Inland Transport Committee

World Forum for Harmonization of Vehicle Regulations**Working Party on Passive Safety Provisions****Sixty-eighth session**

UN Regulation No. 129 (Enhanced Child Restraint Systems)**Proposal for Supplement 5 to the 03 series of amendments to
UN Regulation No. 129 (Enhanced Child Restraint Systems)****Submitted by the expert from the European Association of Automotive
Suppliers***

"Figure 1

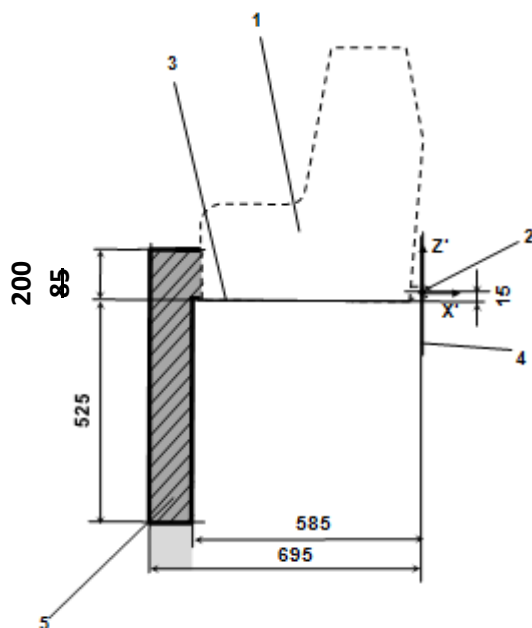
Annex 19., amend Figure 1 to read:

3. UN Regulation No. 16 defines the envelope dimensions of ISO/R2 and ISO/F2X CRF envelopes. The dashed line 2) represents the area where a support leg or similar may protrude. For the ISO/F2X envelope, this is indicated with a height of 200 mm.

In our proposal, the top surface of the support leg volume has been raised upwards to match the support leg opening in the ISO envelopes to facilitate more space for support legs. The majority of the new support leg space already overlaps with ISO/R2 volume and therefore this space is always available in i-Size vehicle positions.

"Figure 2
3D view of the support leg dimension assessment volume

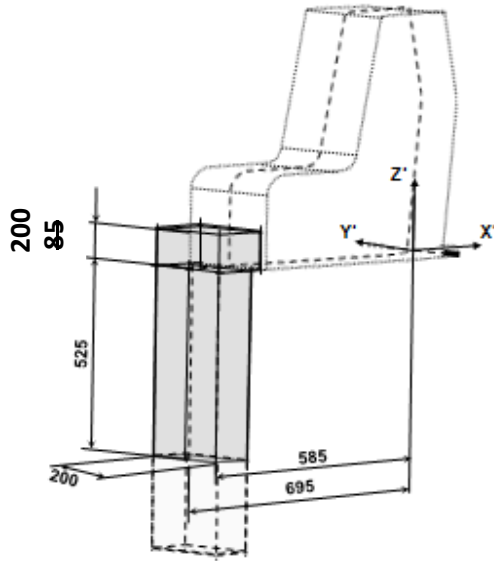
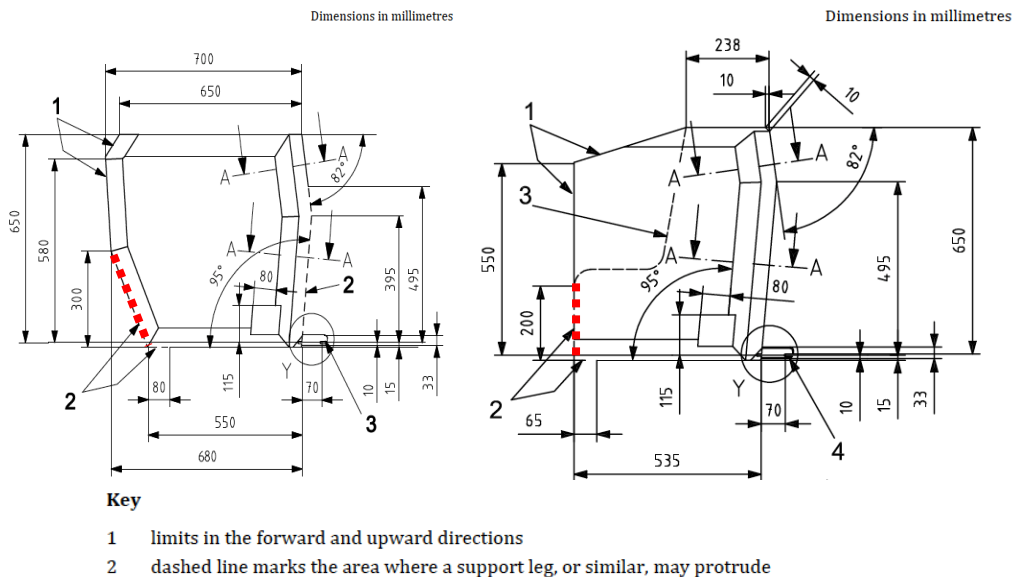
Annex 19., amend Figure 2 to read:
